CIRCUIT COMPARISON

ChryslerScanner

Original schematic -> current circuit sets

Original: Daniel Laszlo, revision 2.4.0-1, 2026-01-05. Current: Rev C, 24 pages / 329 circuit-probe endpoints.

16 Battery, VBB and VPP monitoring dividers

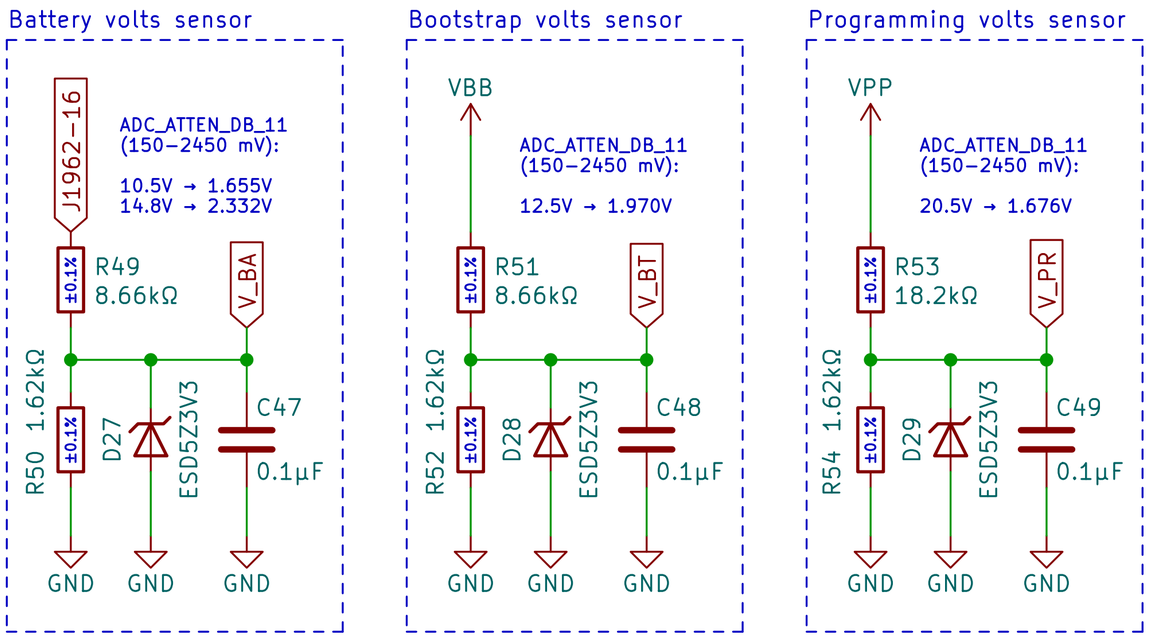
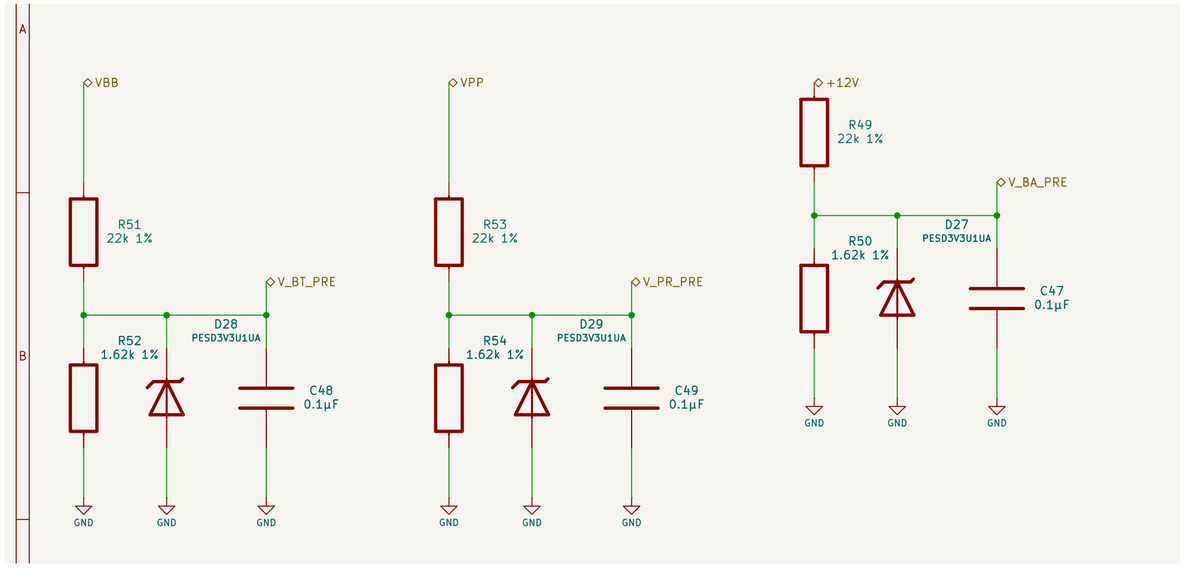
- R49/R51/R53 are now 22k 1%; R50/R52/R54 are 1.62k 1%. R49 input moves to protected +12V.
- The divider outputs are now V_BA_PRE, V_BT_PRE and V_PR_PRE. U21 isolation on the safety page creates the final ADC nets; calibration must reflect these intentional changes.

20 SCI pin 6: VBB / VPP programming switches

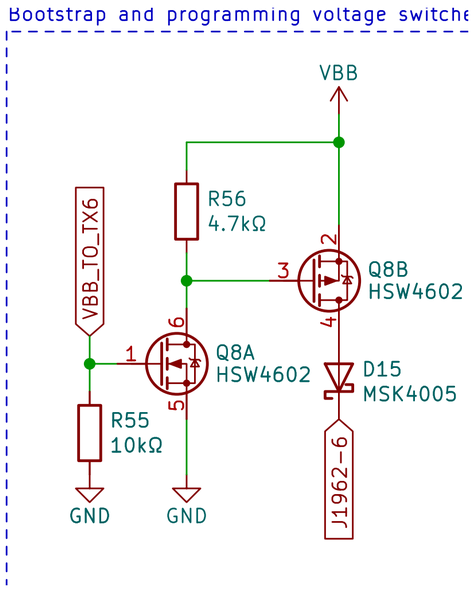
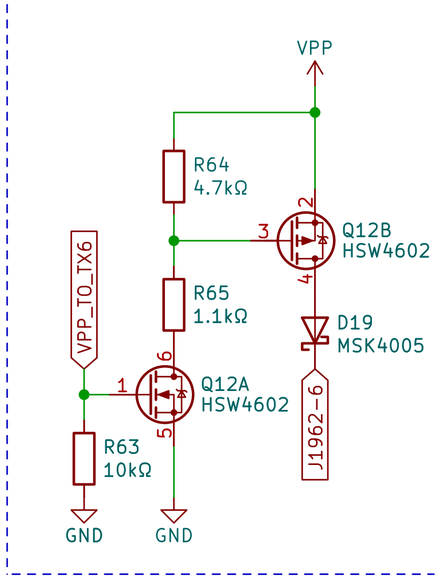
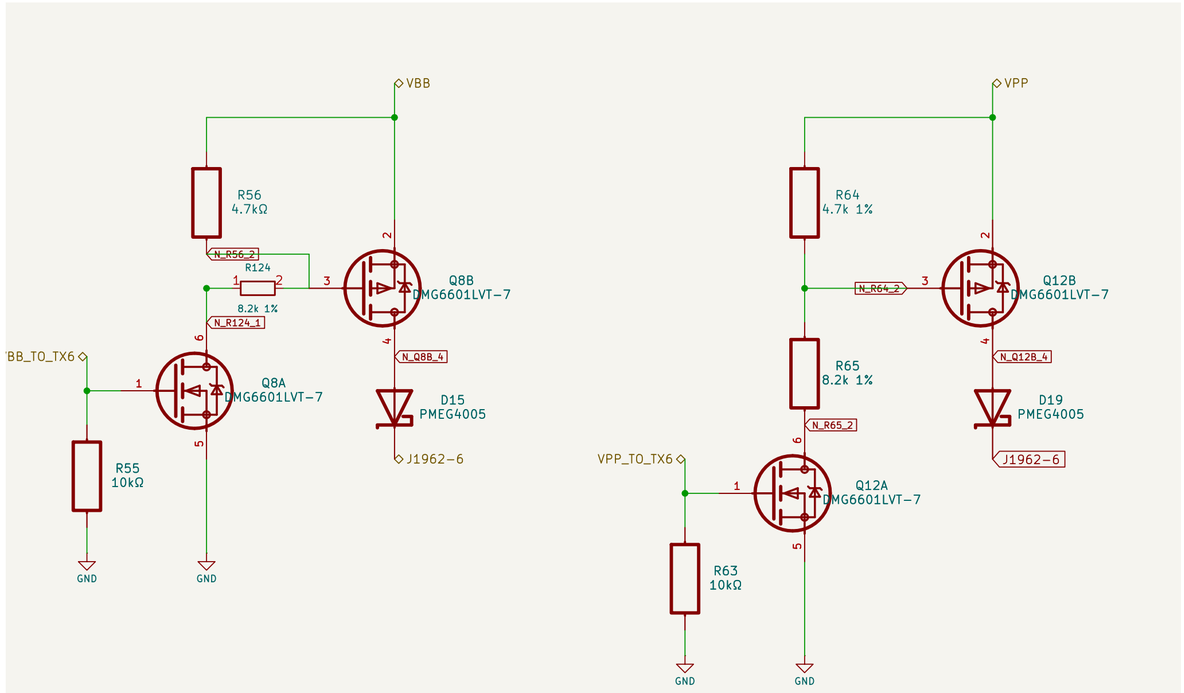
- The two rail-switching branches are paired by vehicle pin on a dedicated page.
- Q8-Q15 now use DMG6601LVT-7, with 2.5 V drive specifications. New R124-R127 give the VBB branches the same 4.7k / 8.2k gate-divider arrangement as VPP; the original direct gate/drain links are intentionally split.

21 SCI pin 9: VBB / VPP programming switches

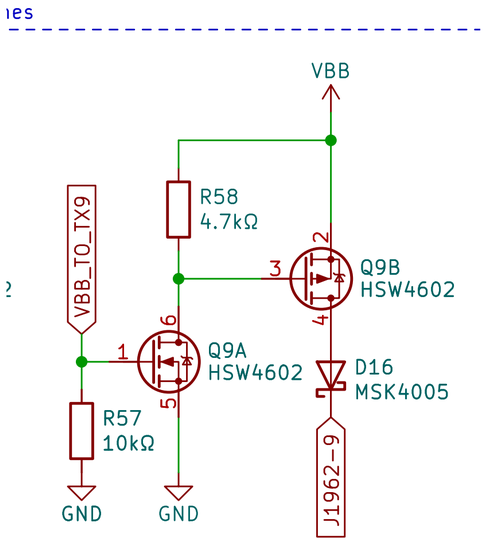
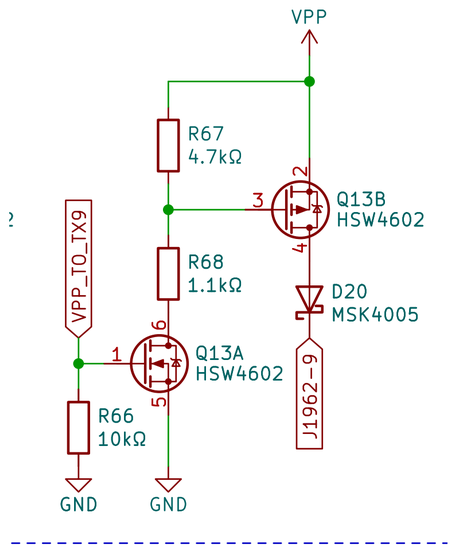
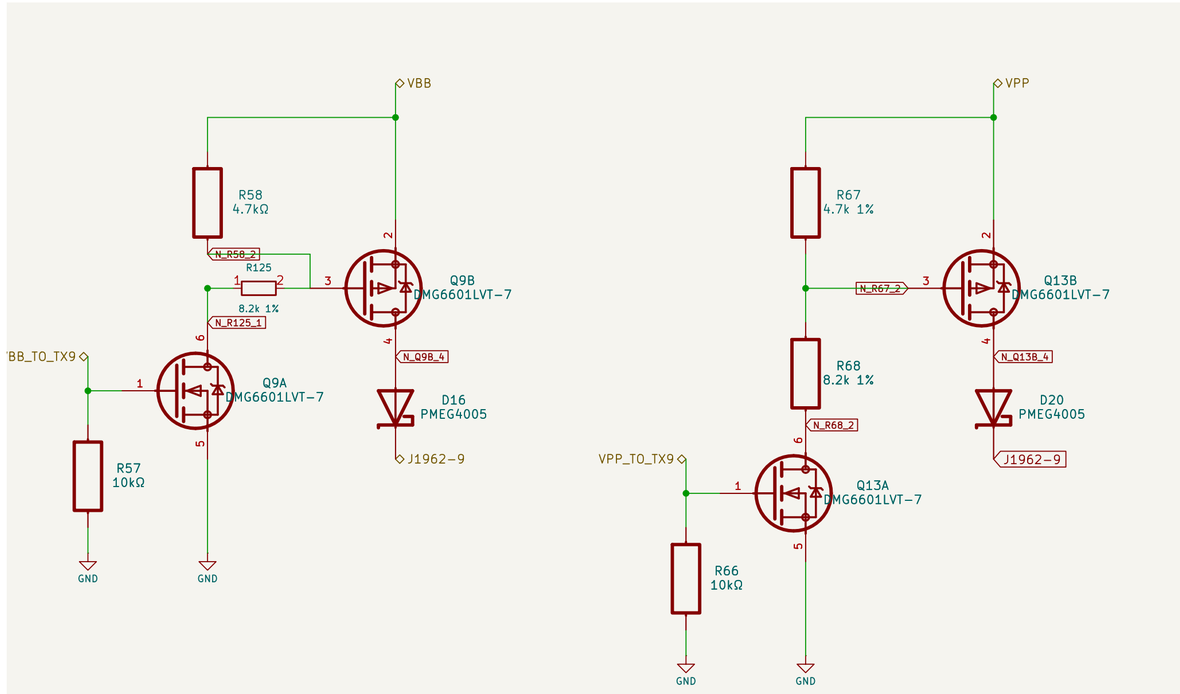
- The two rail-switching branches are paired by vehicle pin on a dedicated page.
- Q8-Q15 now use DMG6601LVT-7, with 2.5 V drive specifications. New R124-R127 give the VBB branches the same 4.7k / 8.2k gate-divider arrangement as VPP; the original direct gate/drain links are intentionally split.

22 SCI pin 12: VBB / VPP programming switches

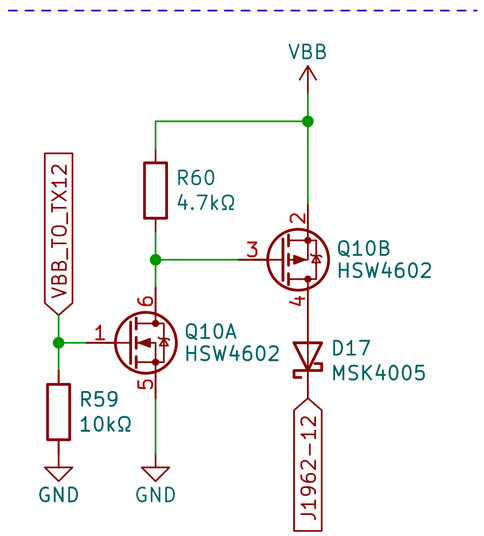
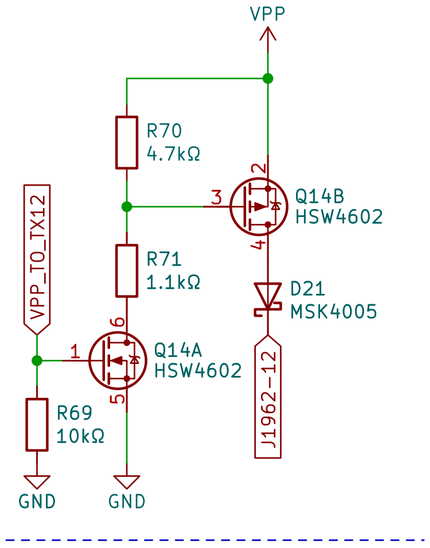
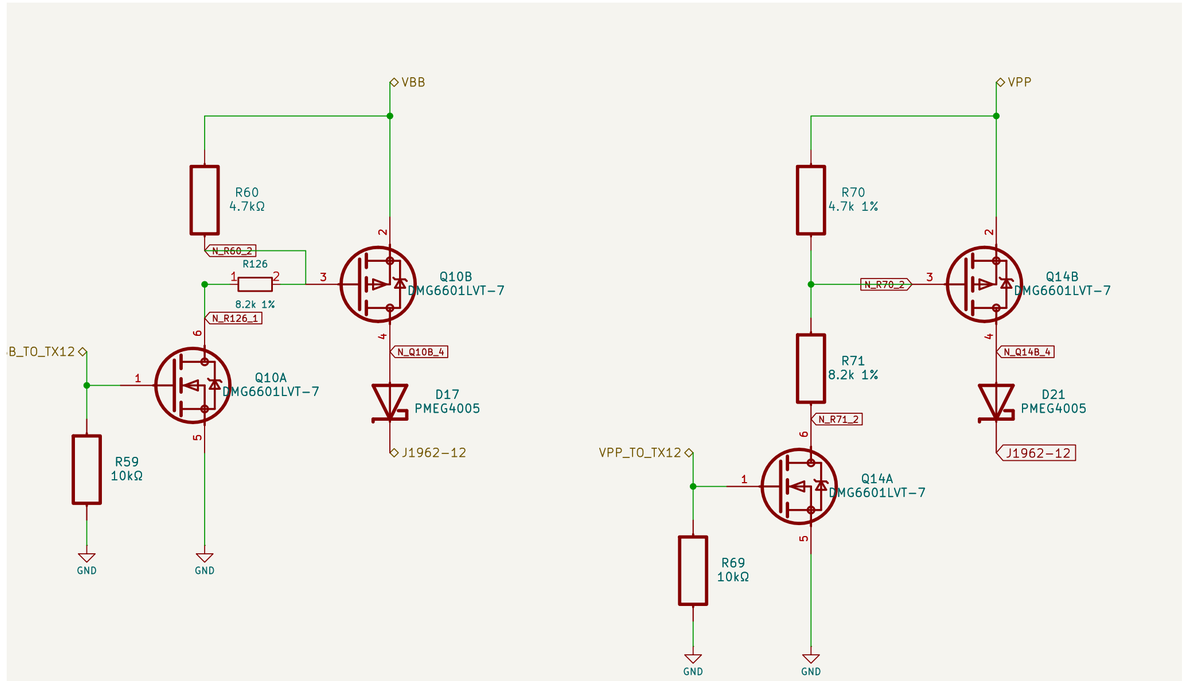
- The two rail-switching branches are paired by vehicle pin on a dedicated page.
- Q8-Q15 now use DMG6601LVT-7, with 2.5 V drive specifications. New R124-R127 give the VBB branches the same 4.7k / 8.2k gate-divider arrangement as VPP; the original direct gate/drain links are intentionally split.

23 SCI pin 14: VBB / VPP programming switches

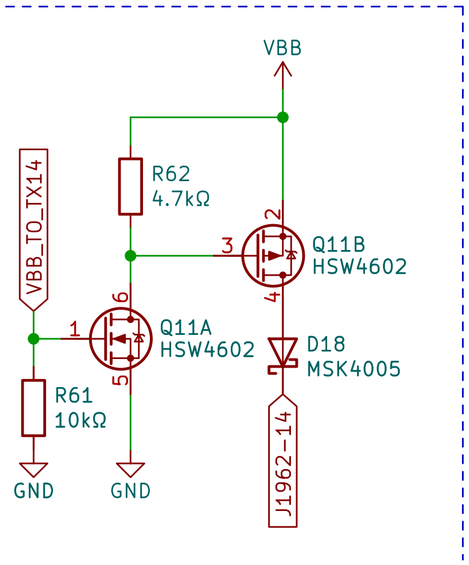
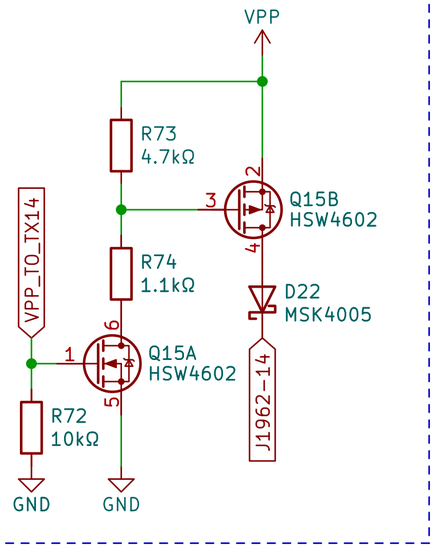
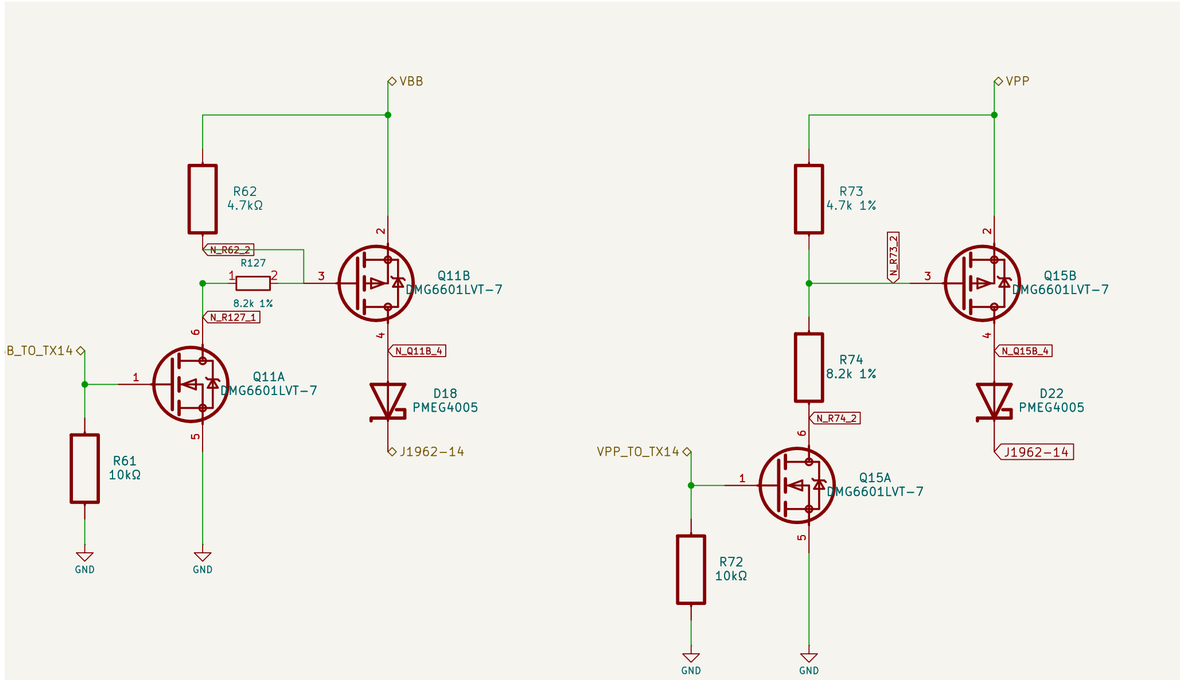
- The two rail-switching branches are paired by vehicle pin on a dedicated page.
- Q8-Q15 now use DMG6601LVT-7, with 2.5 V drive specifications. New R124-R127 give the VBB branches the same 4.7k / 8.2k gate-divider arrangement as VPP; the original direct gate/drain links are intentionally split.

24 I2C expander and internal connector

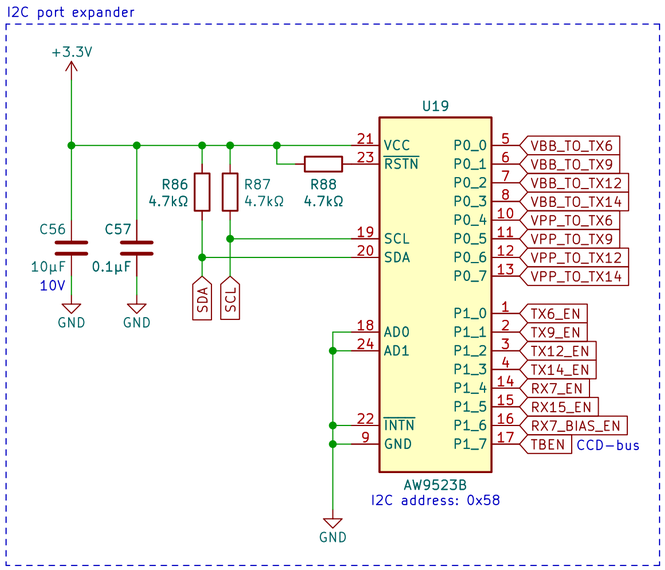
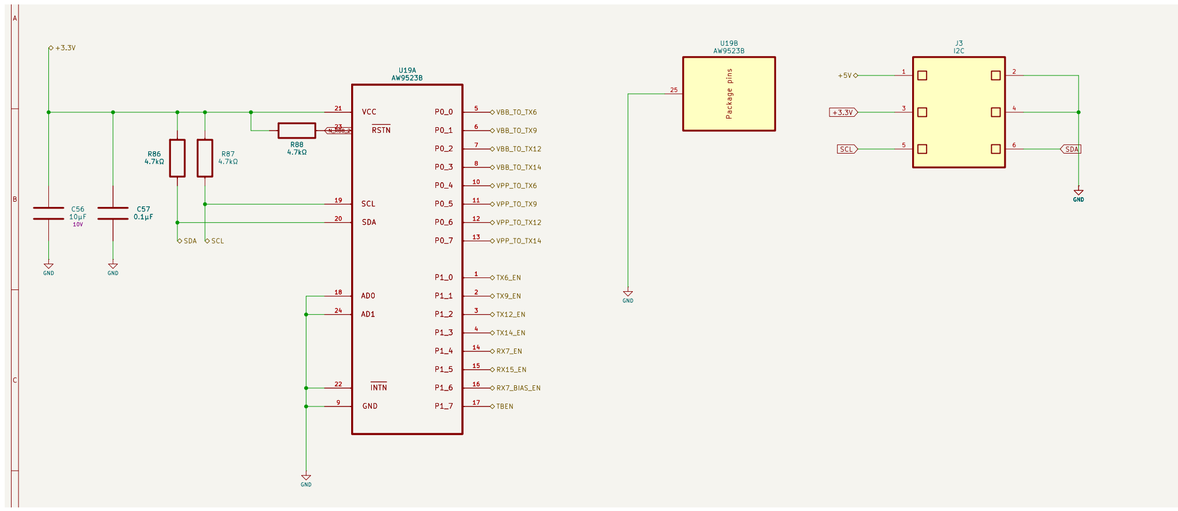
- U19 AW9523B, its 16 output functions, grounded address straps, I2C pull-ups and J3 are retained.
- The reset/permit net N_R88_2 is now driven by the new supervised hardware permit. The original independent reset pull-up is not sufficient by itself to describe the new safety behavior.

25 Status LED drivers

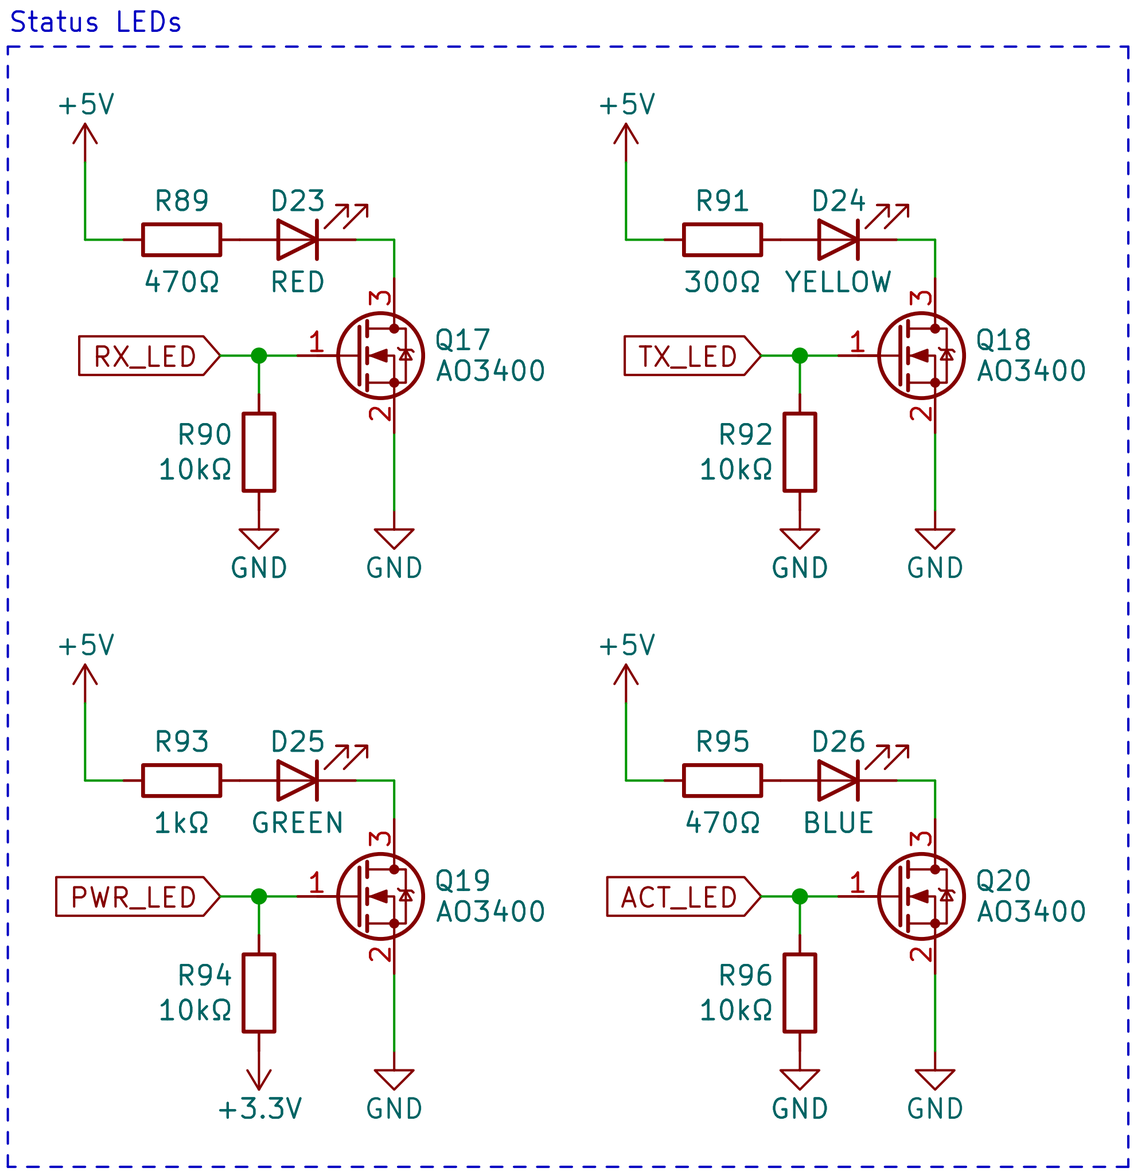
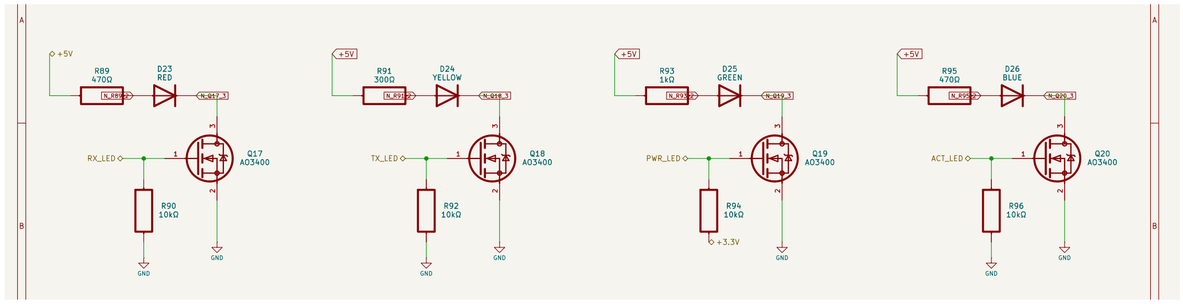
- D23-D26 and Q17-Q20 retain the four LED driver channels.
- The ACT_LED channel is now a dedicated health/permit indication. It must not be driven by the old general-purpose activity-blink code.
